DART AEROSPACE LTD	Work Order:	101940
Description: Crosstube Assembly (205/212 High Aft)	Part Number:	D212-664-241
Inspection Dwg: D212-664-241 Rev: D		Page 1 of 2

DESIGN	PH	DART AEROSPACE LTD HAWKESBURY, ONTARIO, CANADA	
DRAWN	RF		
CHECKED	97	DRAWING NO.	REV. D
MFG. APPR.	SS	D212-664-241	SHEET 2 OF 4
APPROVED	140	TITLE	SCALE
DE APPR.	14	CROSSTUBE ASSY (205/212 HI AFT)	NTS
DATE	09.09.30	<small>COPYRIGHT © 2000 BY DART AEROSPACE LTD THIS DOCUMENT IS PRIVATE AND CONFIDENTIAL AND IS SUPPLIED ON THE EXPRESS CONDITION THAT IT IS NOT TO BE USED FOR ANY PURPOSE OR COPIED OR COMMUNICATED TO ANY OTHER PERSON WITHOUT WRITTEN PERMISSION FROM DART AEROSPACE LTD.</small>

DRAWING NO. D212-664-241	TITLE CROSSTUBE ASSY (205/212 HI AFT)	REV. D	DART AEROSPACE LTD ENGINEERING ORDER		D.E.O. NO. D212-664-241-D-1	SHEET NO. SHEET 1 OF 2	SCALE NTS
DRAWN	CHECKED	MFG. APPR.	APPROVED	DE APPR.			
DATE 11.04.07	DATE 11.04.11	DATE 11.04.12	DATE 11/04/12	DATE 11.04.12

DRAWING NO. D212-664-241	TITLE CROSSTUBE ASS'Y (205/212 HI AFT)	REV. D	DART AEROSPACE LTD ENGINEERING ORDER		D.E.O. NO. D212-664-241-D-2	SHEET NO. SHEET 1 OF 1	SCALE NTS
DRAWN <i>q</i>	CHECKED <i>ASS</i>	MFG. APPR. <i>8</i>	APPROVED <i>MD</i>	DE

D212-664-241/-241B
ASSEMBLY DETAIL

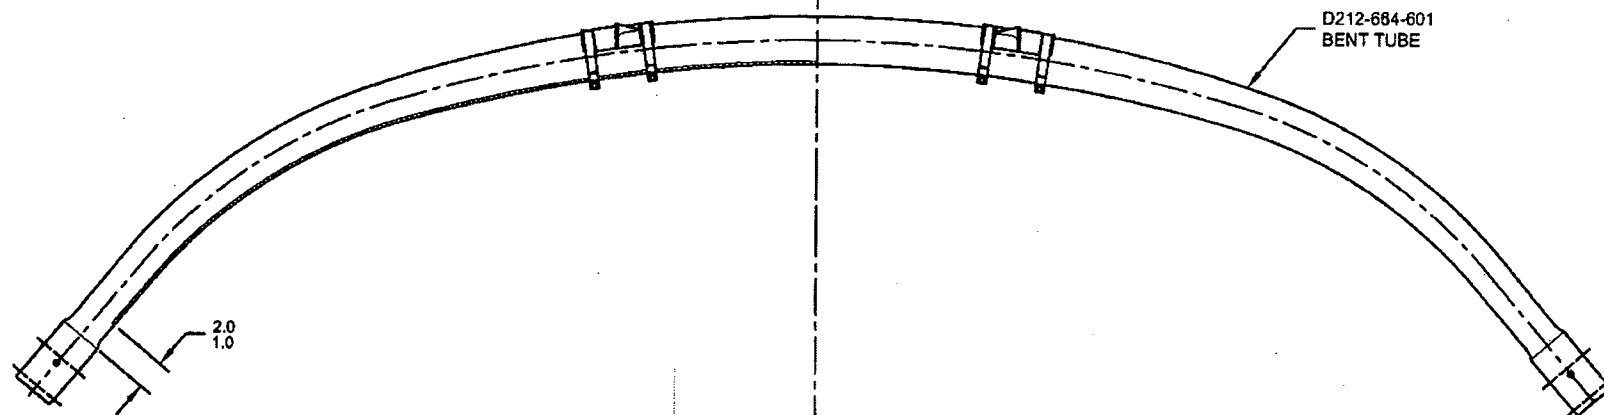
PURPOSE:

ADD AN INSPECTION WINDOW TO UNDERSIDE OF CROSSTUBE.

NOTES 2 OF SHEET 1 IS AMENDED AS FOLLOWS:

- 2) FINISH: CHEMICAL CONVERSION COAT PER DART QSI 005 4.1
PRIME INSIDE AND OUTSIDE PER DART QSI 005 4.2
MASK UNDERSIDE OF CROSSTUBE AS SHOWN (HATCHED AREA) AND
PAINT OUTSIDE PER DART QSI 005 4.2
REMOVE MASKING AND APPLY CLEAR COAT

MASK AREA PRIOR TO PAINTING,
REMOVE MASKING AFTER PAINT
AND APPLY CLEAR COAT
